Service Bulletin

Bulletin No.: 22-NA-138

Subject: Information on Appearance of the Male Buckle on the Front Seat Belt Retractor Being Different in Side to Side Comparison

6116836

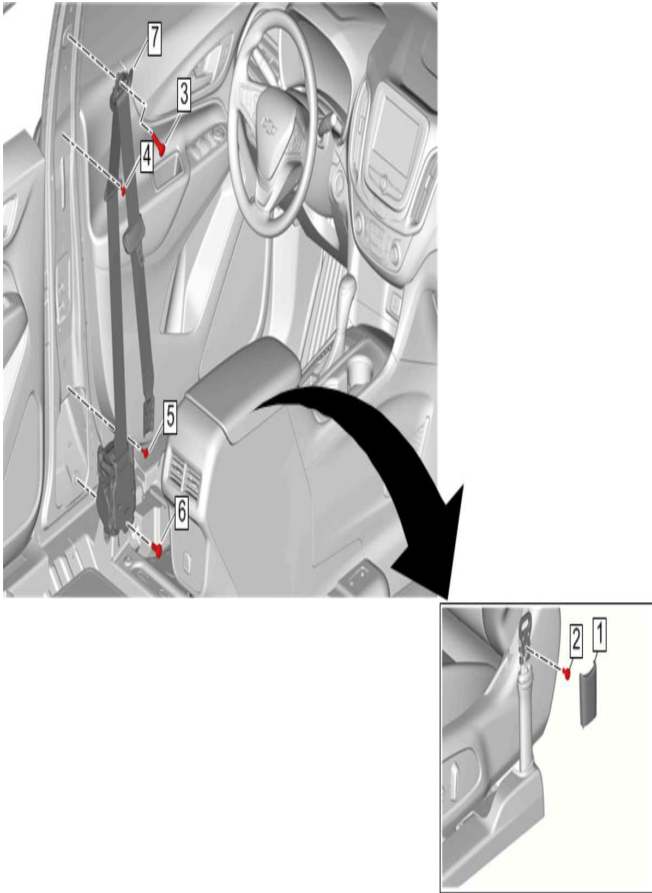
Note: Vehicles may have the original, standard front male buckle (1) on both sides, the temporary, optional front male buckle (2) on both sides, or one of each.

The cause of the condition may be that due to a supplier part shortage, on certain Equinox and Terrain vehicles, an optional, validated male buckle design was temporarily used in production of the front seat belt retractor.

Important: Both designs are fully validated and tested, and there is no functional reason to replace either or both retractors. If both left and right retractors match, DO NOT replace the retractors.

If a customer comments their dissatisfaction with the mixed buckles side to side, the **optional** design retractor (2) can be replaced.
